PCN#: PCN_ETHSx-Stepcode_DE-PCN-20191118

Change Title: New energy store and transport mode for ETHSA

Date of publication: November 2019

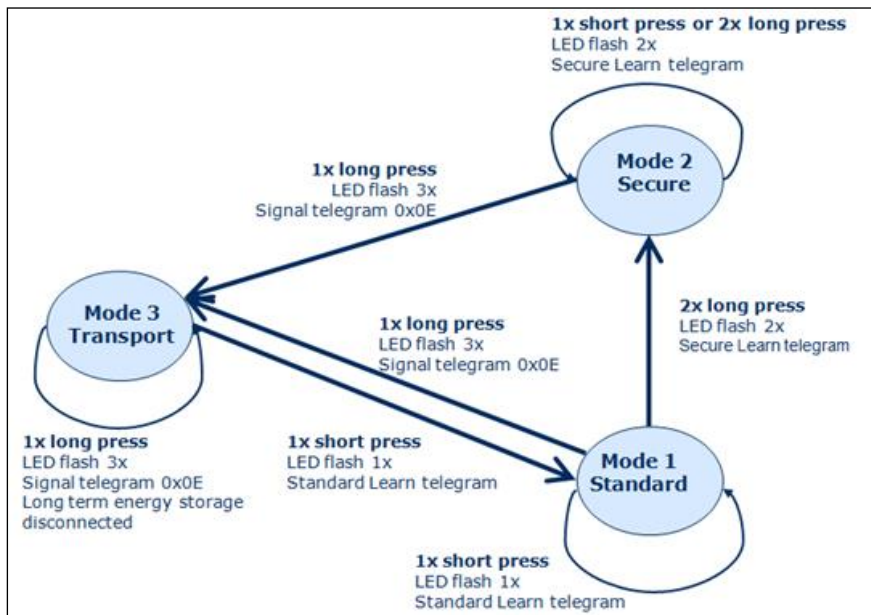
- **Product label and documentation:** Self-created OEM product labels and/ or user documentation have to be updated to reflect the new feature set and consider additional regulatory requirements
- **Waste Treatment, additional regulatory requirement:** A registration according to Battery Directive has been already done for Germany. Since the European Union requires country specific recycling, for all other countries than Germany the OEM customer (B2B) has to register at country specific recycling organizations.
- **Storage:** OEMs might consider putting the final product to transport / storage mode based on their logistic chain
